North Dairy Farm Solar Proposals
Land at North Dairy Farm, Pulham, Dorset
for the 'Save Hardy's Vale' Campaign
Landscape Statement Text
Planning Application Review
665 LS Text Rev P3

Figure 2 - Vegetation Removal

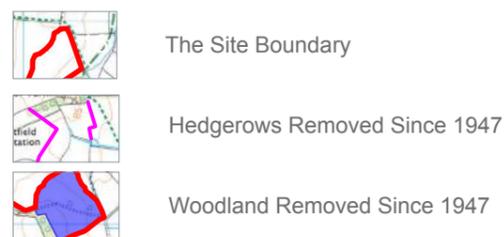
- 3.10 The Site character differs to the general surrounding character. There is a higher proportion of arable fields and some of these are larger than those in the area. Comparing 1947 aerial photographs with the current situation reveals approximately 2.4kms (2,415m) of hedgerow field boundaries and a small woodland of approximately 0.68Ha (6,767m²) have been removed from within the Site creating generally larger fields than those generally typical of the area. Residual hedgerow oaks remain stranded within the arable fields. A large part of Humber Wood (approximately 6.58Ha/65,803m²) just outside and west of the Site boundary has also been removed. This is different to the general surrounding landscape pattern and land use which has largely been unaltered and has remained broadly intact and unharmed over generations - see Figure 2, Page 4.
